Metro Knitting & Dyeing Mills Ltd (Factory-02) New Building

Charabag, Ashulia, Savar, Dhaka- 1341
(23.883822, 90.310283)
4th October 2021

1. Building-3 (Green Project) -(B+G+8)

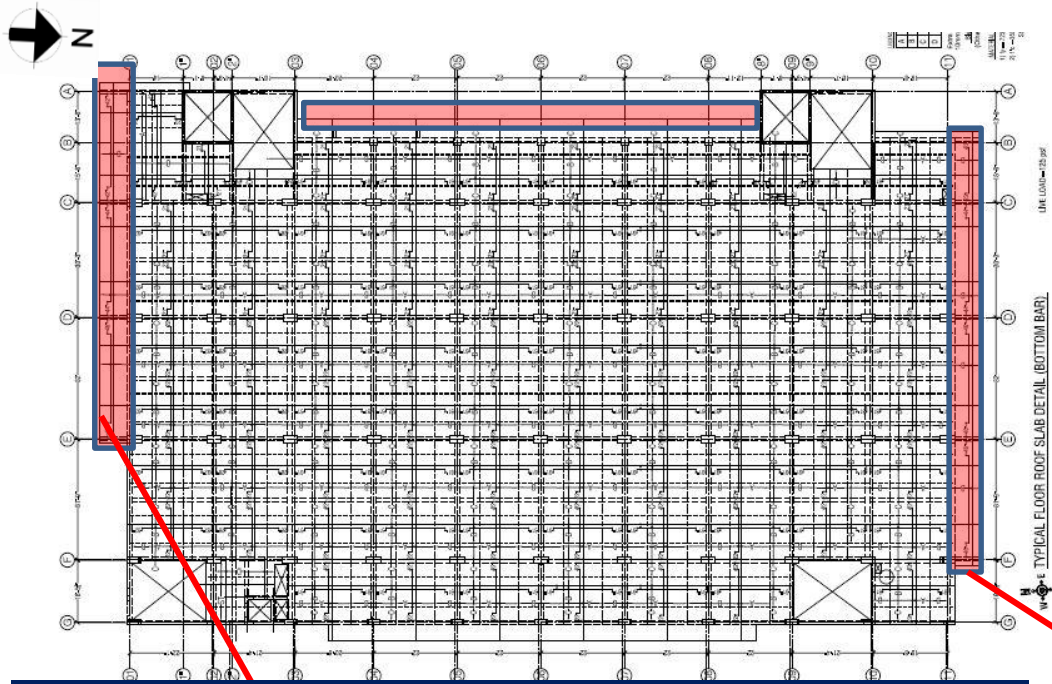
Beam & slab detail were not shown in as-built drawing for any of the staircases

Beam & slab detail were not shown in as-built drawing for any of the staircases. Factory engineer is required to update the as-built drawing showing details of all the structural elements.

Cantilever dimension was not shown in as-built drawing

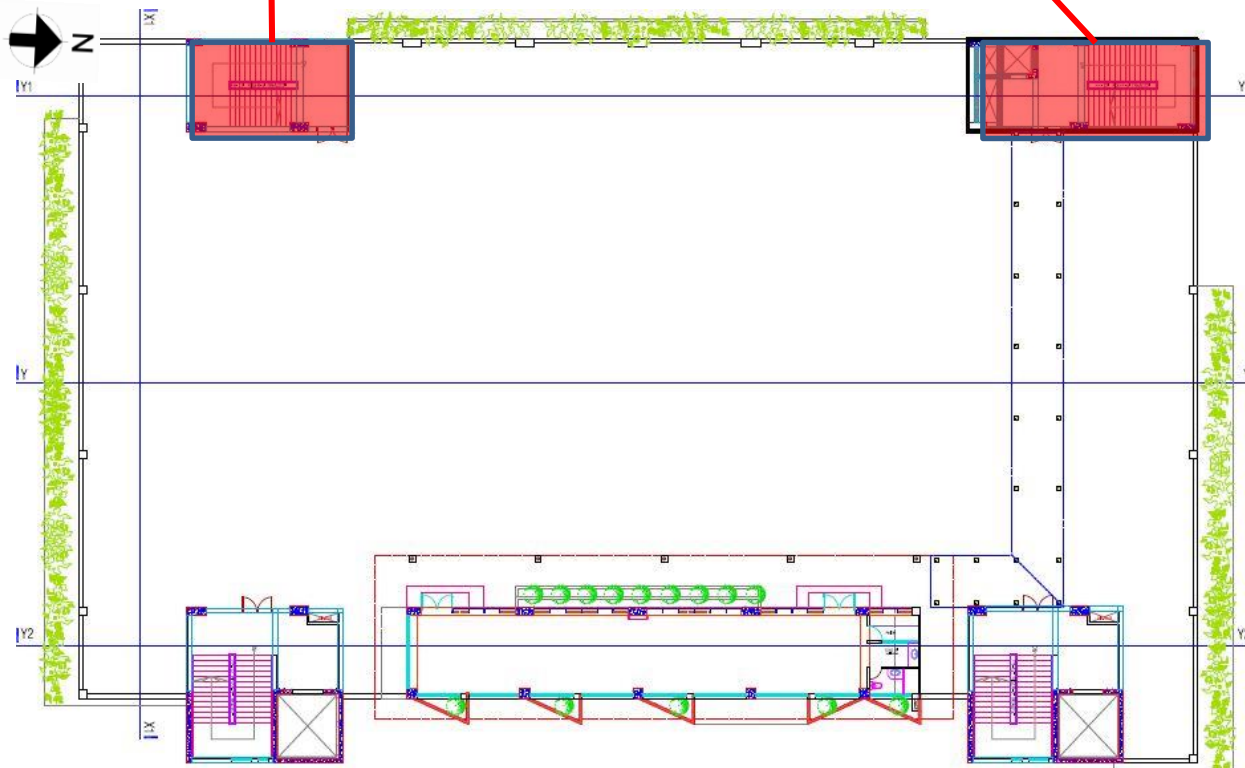
Cantilever dimension was not shown in as-built drawing. Factory engineer is required to update the as-built drawing showing dimension of all the structural elements.

Cantilever at south side

Cantilever north side

Extension at north side

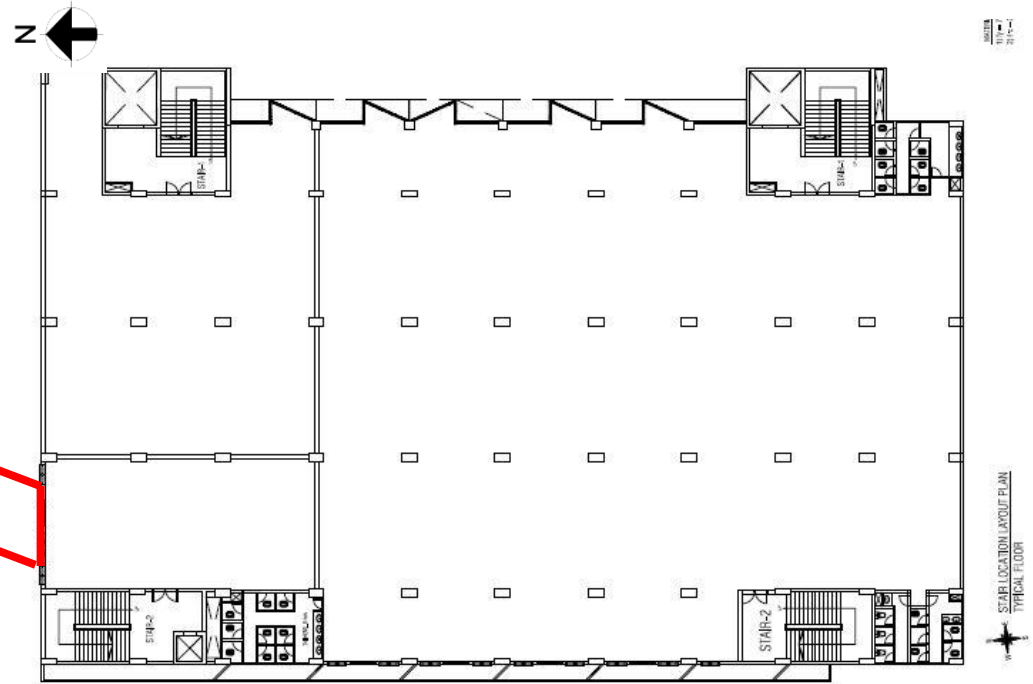
Extension at north side was not shown in archliberal drawing. Factory engineer is required to update the as-built drawing showing the extension.
